CITY OF ALBUQUERQUE

Re: Chase Bank – Eubank
340 Eubank Blvd NE, 87123
Request for Certificate of Occupancy
Transportation Development Final Inspection
Engineer's/Architect's Stamp dated 9-2-20 (K21D009C)
Certification dated 4-26-21

TRAFFIC CIRCULATION PLAN
340 EUBANK BOULEVARD NE
CITY OF ALBUQUERQUE, NEW MEXICO
BERNALILLO COUNTY

PLOT DATE	09/02/20
DRAWING SCALE	1" = 10'
PROJECT NUMBER	CDC20014
SHEET NUMBER	C1.02

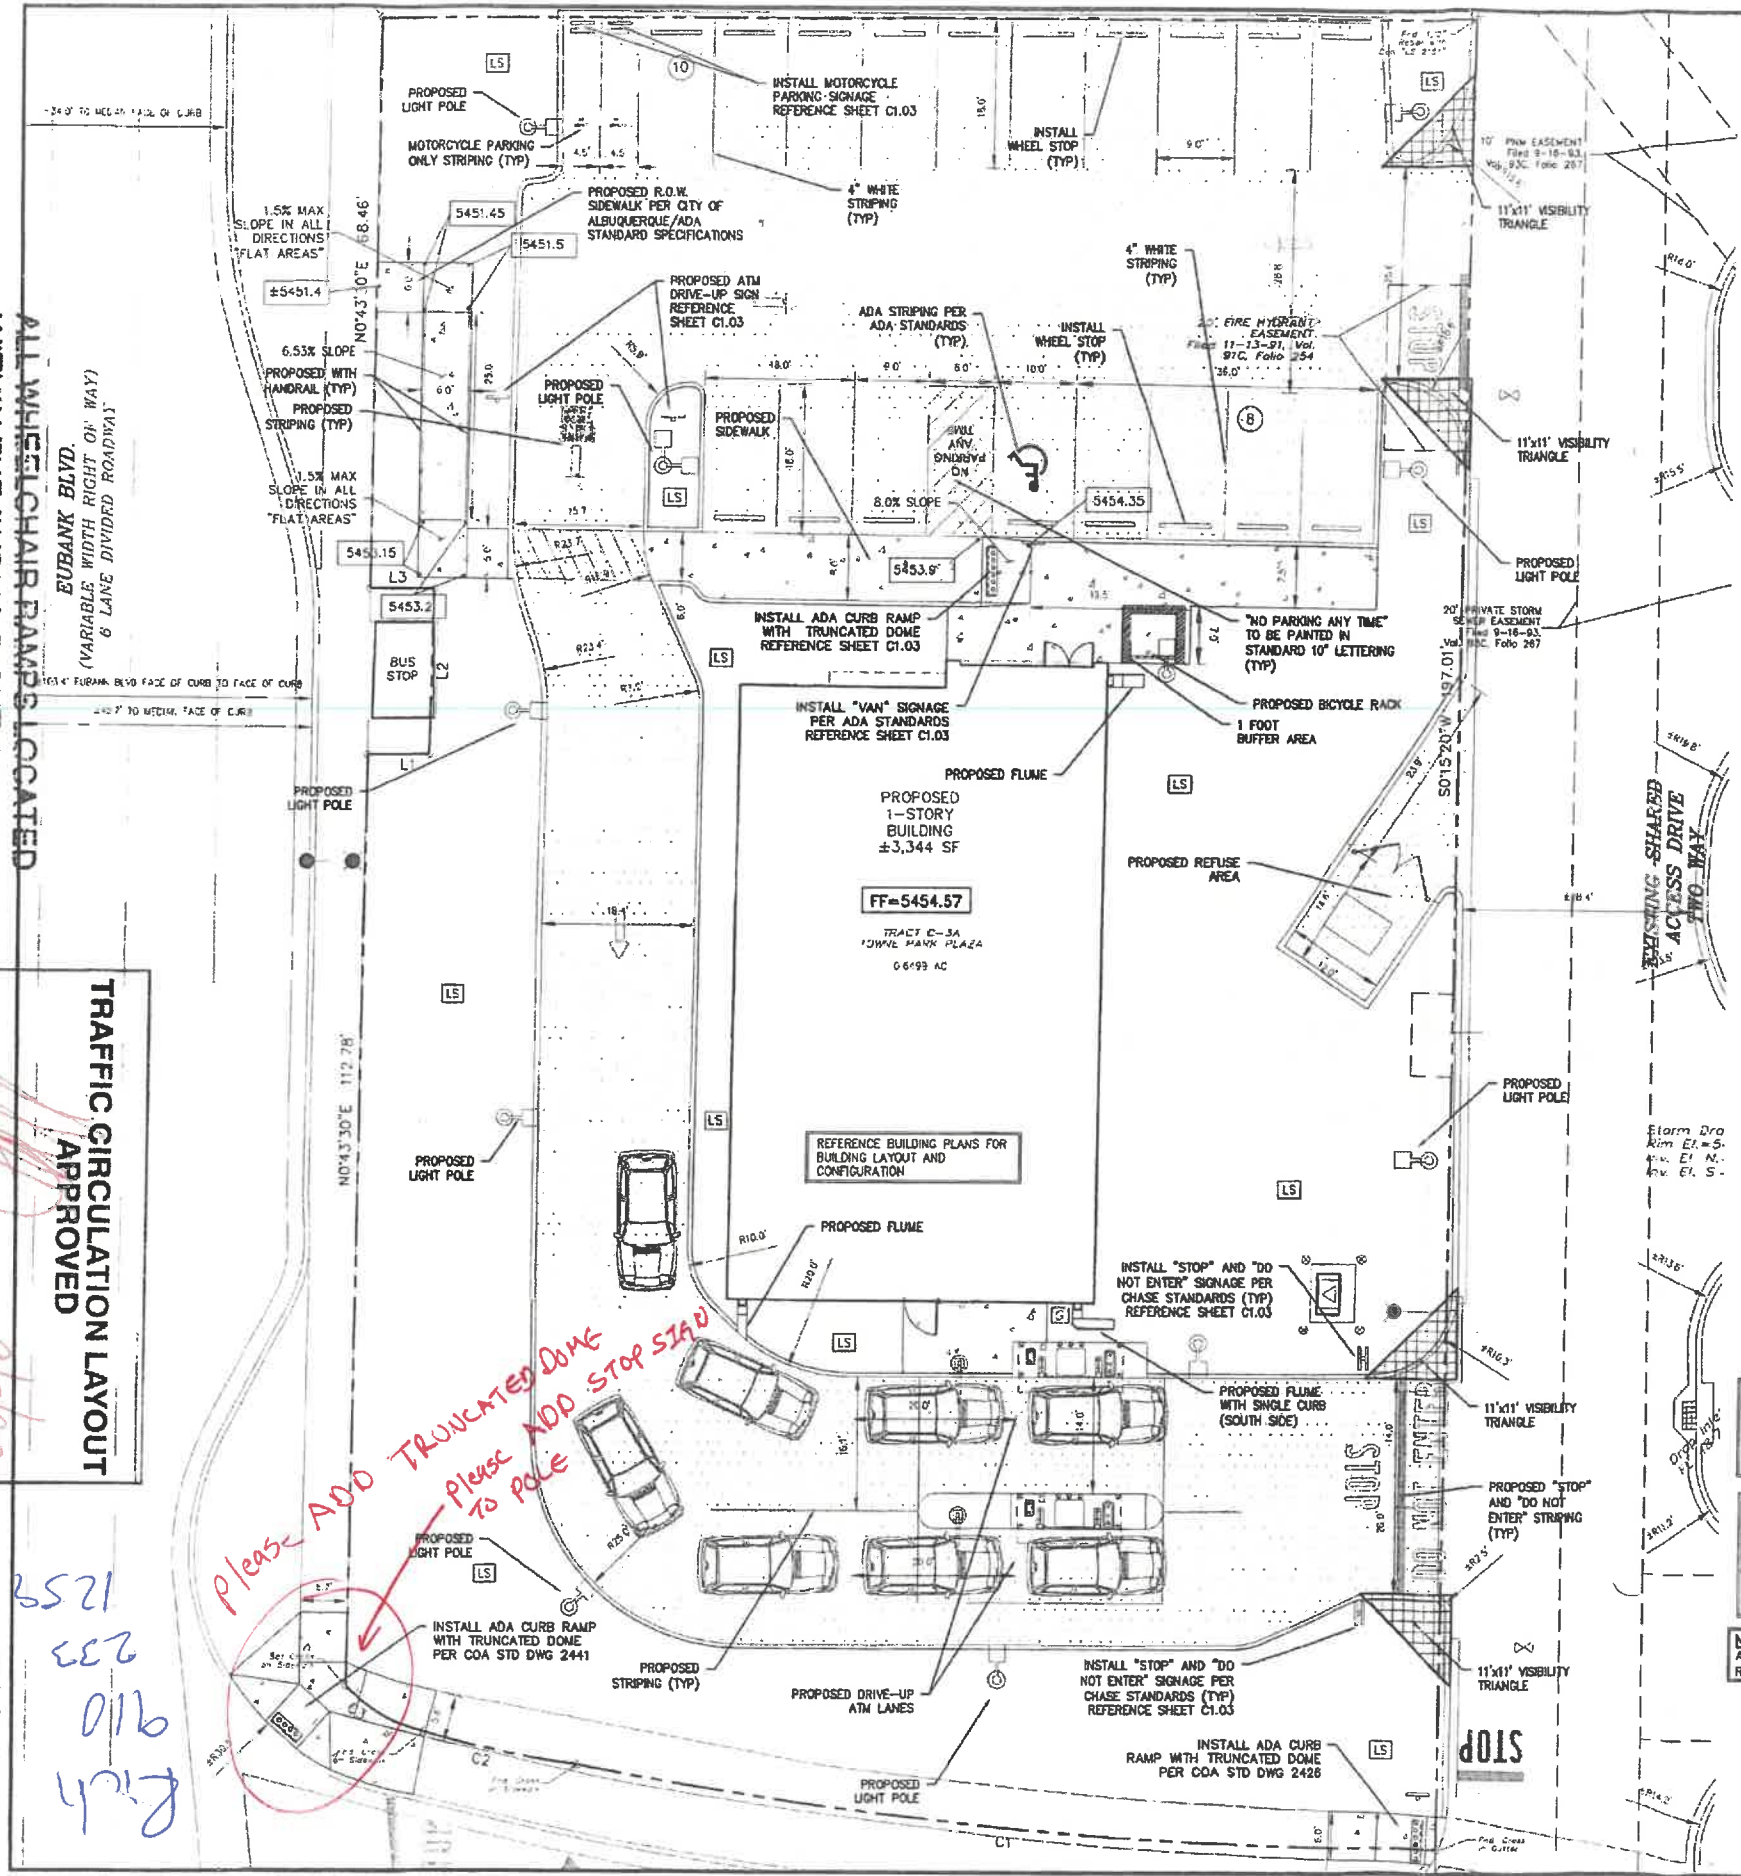
Please ADD TRUNCATED DOME
Please ADD STOP SIGN
to pole

Two missing stop signs need to still be installed.

Based upon the information provided in your pictures received 5-3-21, Transportation Development has no objection to the issuance of a Permanent Certificate of Occupancy. This letter serves as a "green tag" from Transportation Development for a Permanent Certificate of Occupancy to be issued by the Building and Safety Division.
